ADDENDUM NO. 3

**Upgrades and Renovations
Missouri Veterans Home
Cape Girardeau, Missouri
Project No.: U1805-01 (FAI 29-043)**

Bid Opening Date: 1:30 PM, Tuesday, February 4, 2020

CENTRAL CORE HYDRONIC PLAN

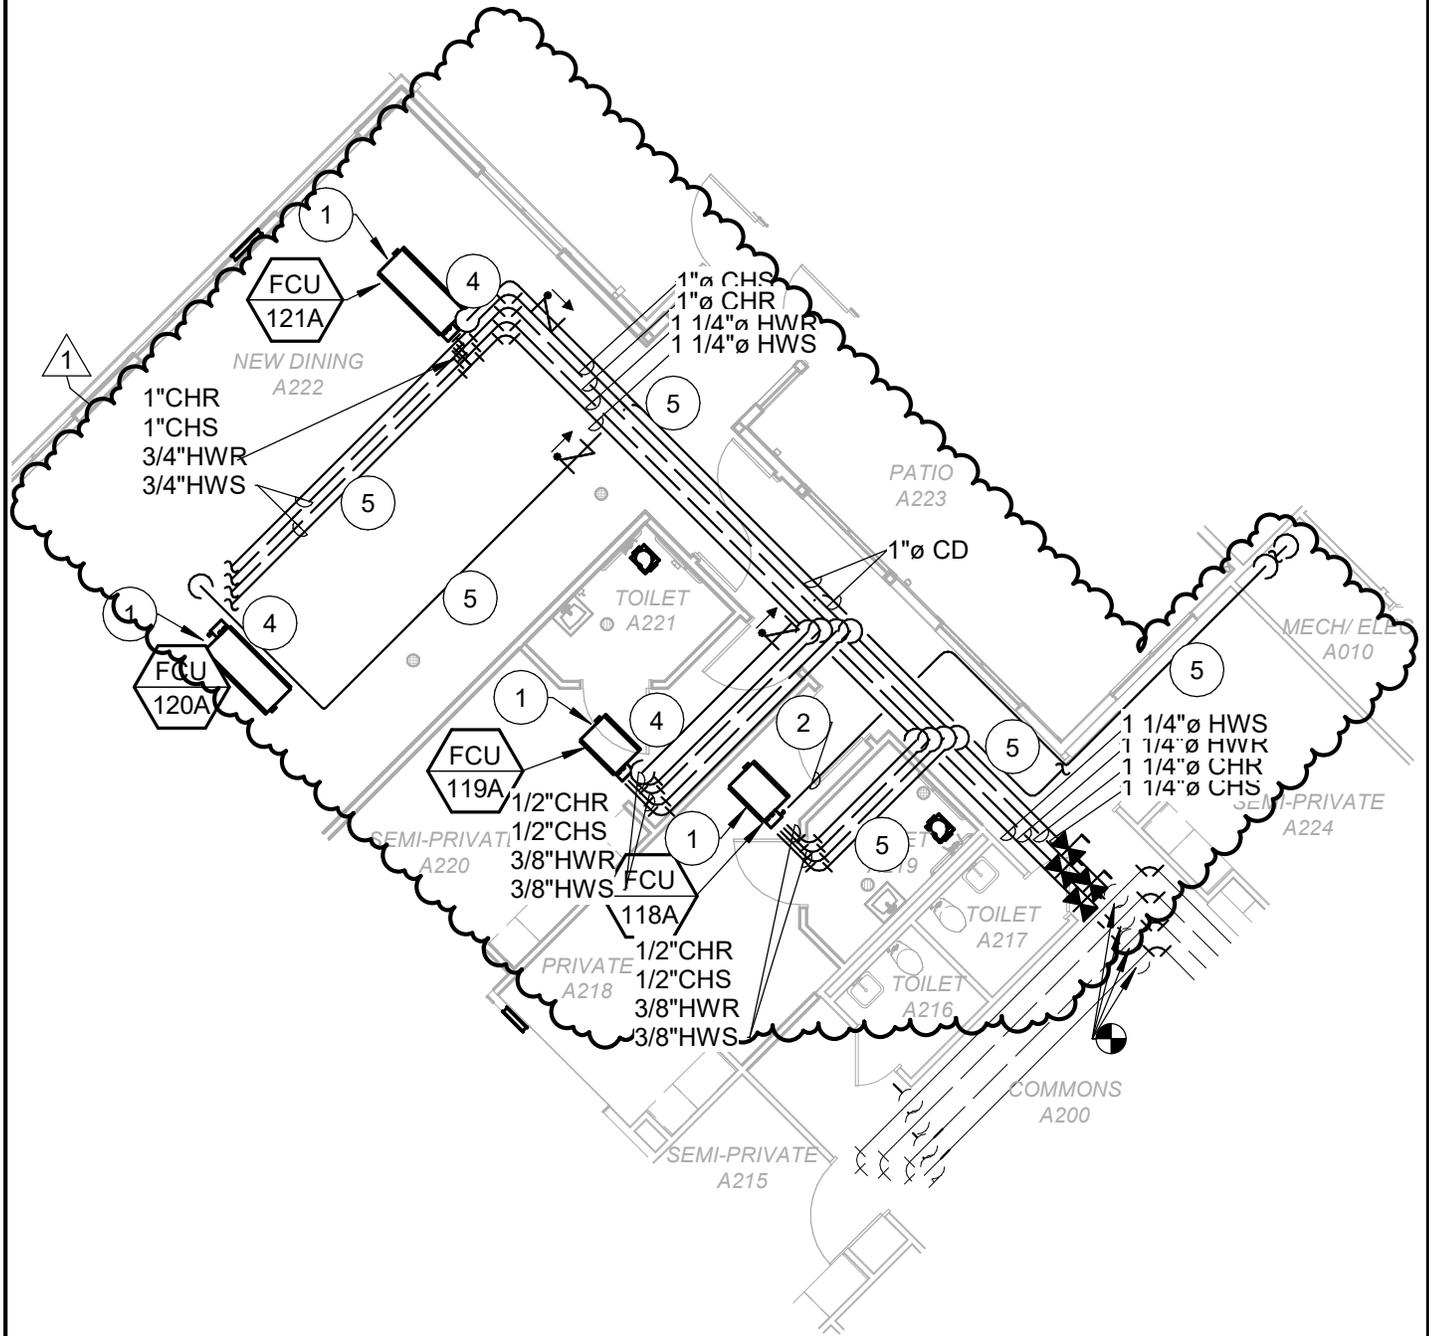
- a. REVISE piping sizes and layout as shown on attachment SD-M-111.1.

- a. REVISE piping sizes and layout as shown on attachment SD-M-112.1.
- b. ADD Keynote 5 as indicated on attachment SD-M-112.1

5 COORDINATE HYDRONIC AND CONDENSATE DRAIN PIPING ROUTING WITH WOODEN TRUSSES AND DUCTWORK ABOVE CEILING.
